Product Change Notice (PCN)

PCN Number: **PCN-0450972R-01**

Product(s) Affected: *SJ1-351XN Series. (SJ1-3513N, SJ1-3514N, SJ1-3515N)*

| PREVIOUS CUI DEVICES DETAIL / IMAGE | | | NEW CUI DEVICES DETAIL / IMAGE | | |

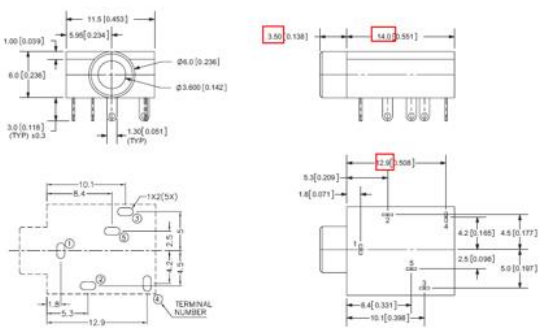
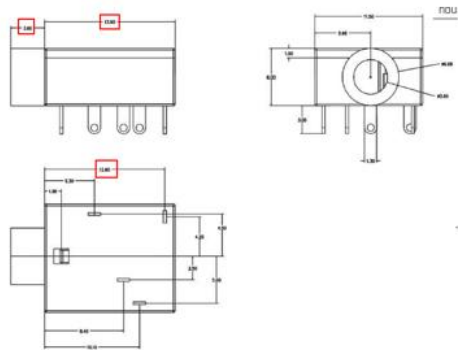
Reason(s) for Change: *Tooling and Material Change*

Description of Change: *Slight Dimensional difference. Terminal Material Change See image Below*

| PREVIOUS CUI DEVICES DETAIL / IMAGE | | | NEW CUI DEVICES DETAIL / IMAGE | | |
|---|-----------------|---------|--|-----------------------|---------------|
| terminal 1 | brass | silver | terminal 1 | brass t=0.3 | silver |
| terminal 2 | brass | silver | terminal 2 | phosphor bronze t=0.3 | silver |
| terminal 3 | brass | silver | terminal 3 | brass t=0.3 | silver |
| terminal 4 | brass | silver | terminal 4 | brass t=0.3 | silver |
| terminal 5 | brass | silver | terminal 5 | phosphor bronze t=0.3 | silver |
| bushing | brass | nickel | bushing | brass | nickel |
| spring | stainless steel | | spring | steel | black |
| cover | PBT | | cover | PBT (UL94V-0) | black |
| plastic | PBT | | housing | PBT (UL94V-0) | black |
